**FINDINGS AND RECOMMENDATION
OFFICE OF PLANNING AND ZONING
ANNE ARUNDEL COUNTY, MARYLAND**

CASE NUMBER: 2025-0233-V

The applicants are requesting a variance to allow the conversion of an accessory structure (detached garage) into an accessory dwelling unit and a storage and work area with less setbacks than required and located in the front yard of a nonwaterfront lot at 420 Fairhaven Road in Tracy's Landing.

PRE-FILE #: 2025-0107-P
DATE: 11/20/2025
OPZ STAFF: Jennifer Lechner
I&P STAFF: Natalie Norberg

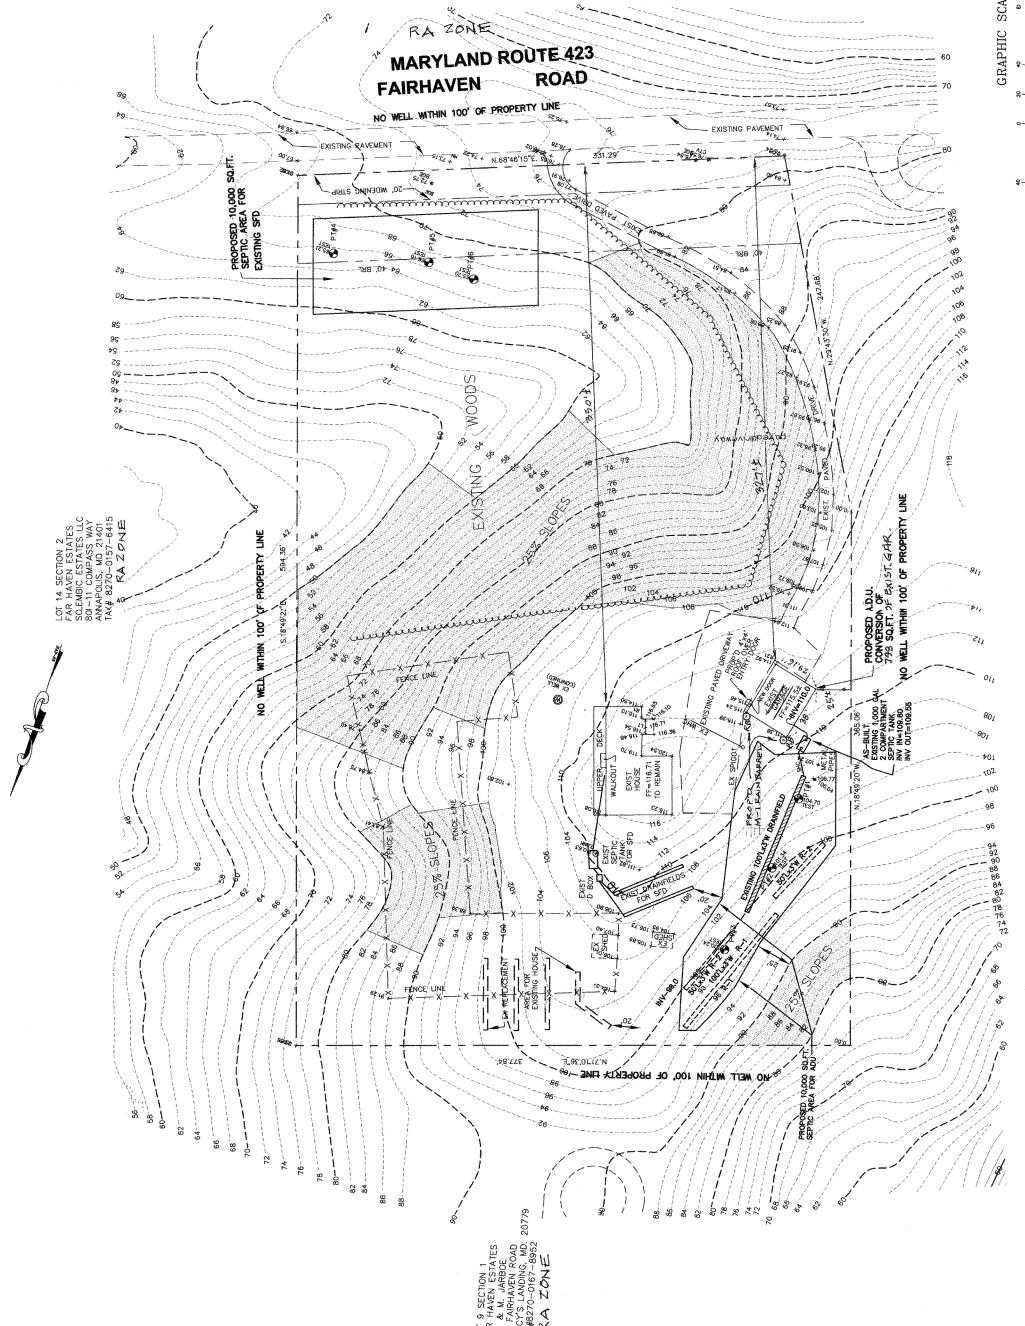
² Bill 72-24, effective July 1, 2025, changed the setbacks and coverage by structures for the R2 - Residential District. The site plan shows the prior regulations and should be updated on future applications to reflect the proper setbacks and coverage by structure.

1. Show and label any existing and proposed stormwater management devices. All SWM devices must meet setbacks to the proposed septic trenches and septic reserve area.
2. Does the existing well meet the requirements for the ADU fire suppression and domestic water needs? A Fire Department review may be required.

NOTE: A 55 Gal M-1 Rain Barrel (RB) is proposed to be placed at each downspout from the garage roof (2 Rain Barrels total proposed) to treat the existing roof runoff. Each rain barrel will be equipped with 50L of pebbles to attach to the downspout on the barrel. Refer to MDE Ch. 5, Fig. 5-6 for detail. The proposed rain barrels shall be maintained in accordance with the manufacturer's specifications.

Zoning #1. We have added the dimensions of the existing garage to the site plan.

I&P Engineering #1. We note that the assigned I&P Engineering reviewer of the BP application approved the Site Plan as presented with the BP application B02440840 for the proposed ADU conversion. However, the owner/applicant will amend the Building Permit Site Plan to propose the installation of a 55 gallon Rain Barrel as shown on the Variance Site Plan at each downspout on the existing garage (2 rain barrels total) in order to address this Engineering Variance Pre-file review comment. We again note that the structure exists and is situated outside of the Critical Area and that no new lot cover or disturbance is proposed outside of the existing footprint.
